SUB-COMMITTEE ON SHIP DESIGN AND
CONSTRUCTION
6th session
Agenda item 7

SDC 6/7/Add.3
21 September 2018
Original: ENGLISH

AMENDMENTS TO THE 2011 ESP CODE

Consolidated version of the ESP Code (part 4)

Figure 1: ~~Maximum water level in a tank~~

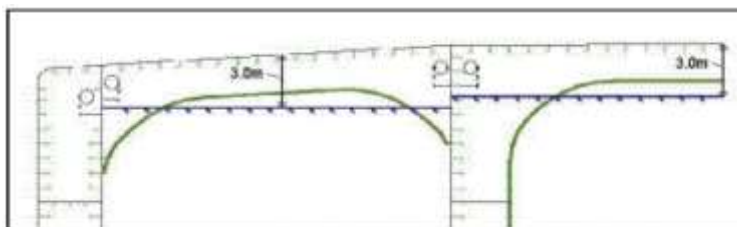
- .2 access to deck from a longitudinal permanent platform having ladders to deck in each end of the tank. The platform ~~should is~~, for the full length of the tank, ~~to~~ be arranged in level with, or above, the maximum water level needed for rafting of under deck structure. For this purpose, the ullage corresponding to the maximum water level ~~should is to~~ be assumed not more than 3 m from the deck plate measured at the midspan of deck transverses and in the middle length of the tanks (see figure 1).
